ILLINOIS POWER COMPANY

Subject: Clinton Power Station (CPS) Unit 1
TMI Action Plan Item II.F.1. "Additional
Accident Monitoring Instrumentation"

Illinois Power Company Justification for
Not Adding Heat Tracing to the High-Range Effluent
Monitor Grab Sample Pallet Sample Lines

FIGURE 1

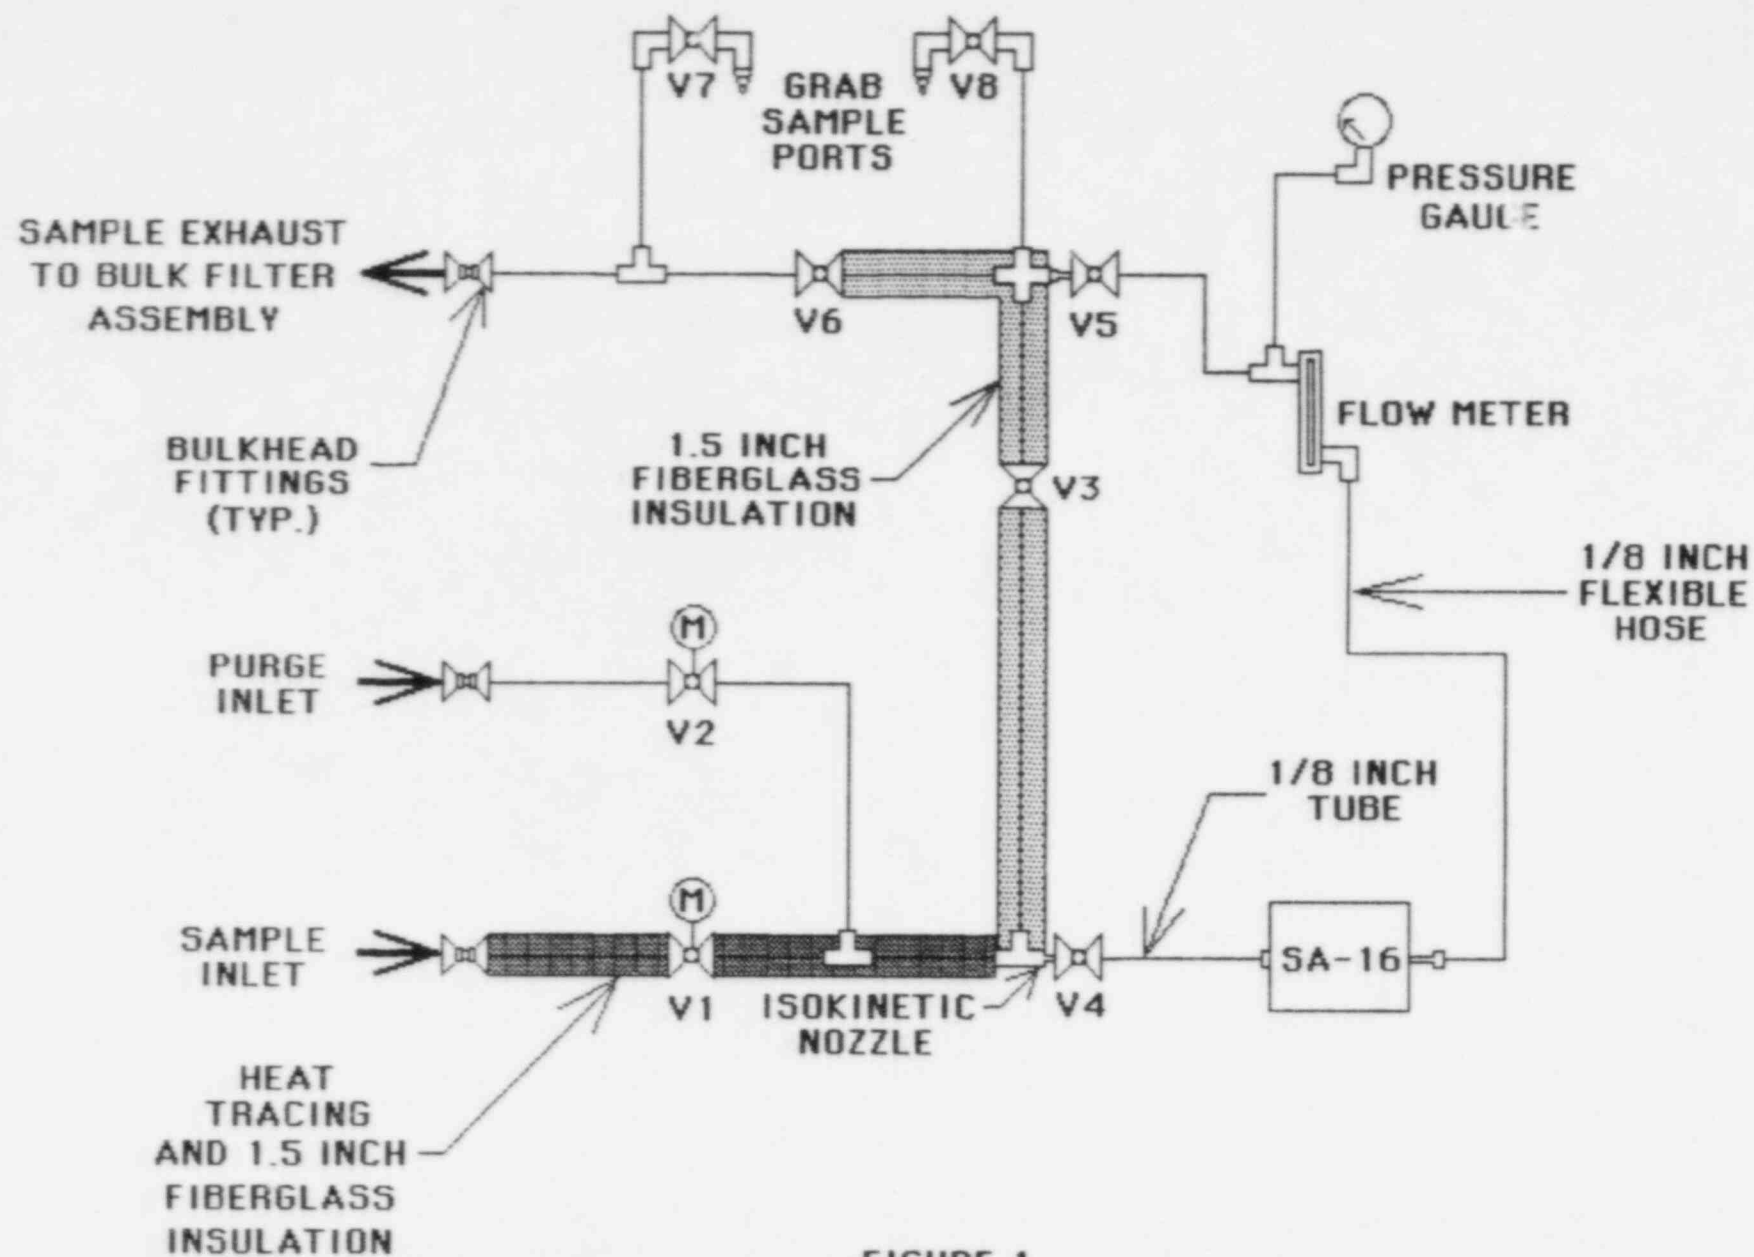
The NRC has indicated a need for additional heat tracing on the sample lines at the inlet and outlet of the SA-16s for both AXM-1s. IP believes that this is neither feasible or practical for the following reasons:

- 1) The AXM-1 sample line heat tracing used consists of ceramic heating elements encased in a corrugated inconel sheath (which is approximately 1 inch in width-long face). Due to the construction of the heat tracing (purchased to ensure seismic

and environmental qualification) the allowable bending radius will not conform to the routing of the 1/8 inch SA-16 inlet tubing. The 1/8 inch inlet tubing has an unsupported bend which allows flexibility for removing it from the SA-16s. The tubing which leaves the SA-16s is flexible metal hose which further complicates the problem. The tubing to and from the SA-16s must be flexible to allow quick and easy removal of the SA-16s (for transport to the lab), due to the radiological conditions that would be evident after an accident, for minimizing operating personnel radiation doses.

- 2) If the heat tracing was extended onto the 1/8 inch SA-16 tubing, the potential for moisture condensation in the SA-16s would still exist because the heavy lead shielding will never reach the temperature of the sample. If the SA-16s were heat traced it would create a handling problem. The heat trace circuits and thermocouples would have to be disconnected prior to allowing the SA-16s to be removed from the GSP-1s for transport to the lab. Also, the temperature of the SA-16 (up to 180°F) would make it difficult to handle. In addition to these problems, replacing the SA-16 to take another grab sample would present more difficulties. The replacement SA-16 would be at ambient temperature which would prevent operation of the GSP-1 until the SA-16 reached the sample temperature, or the next grab sample (if started immediately after changing the SA-16) would again have the potential for moisture condensation in the SA-16.

As can be seen from Figure 1, the 3/8 inch tubing makes a 90° bend at the isokinetic nozzle and is routed vertically upwards where it again joins with the 1/8 inch tubing coming from the SA-16. The sample line then exits the GSP-1 and is routed to the bulk filter assembly (BFA-1). To minimize the amount of condensation in the vertical portion of the 3/8 inch tubing on the GSP-1, 1½ inches of fiberglass insulation is utilized. The insulation extends from the isokinetic nozzle to isolation valve V6. The amount of moisture condensing in the vertical line is expected to be very small. (This will be verified by performing a thermal analysis.) Considering the design of the isokinetic nozzle, the likelihood of plugging is very small. (The end of the nozzle actually extends past the edge of the elbow into the heat traced portion of the 3/8 inch tubing.) Heat tracing is utilized for the sample line between the outlet of the GSP-1s to the BFA-1s.
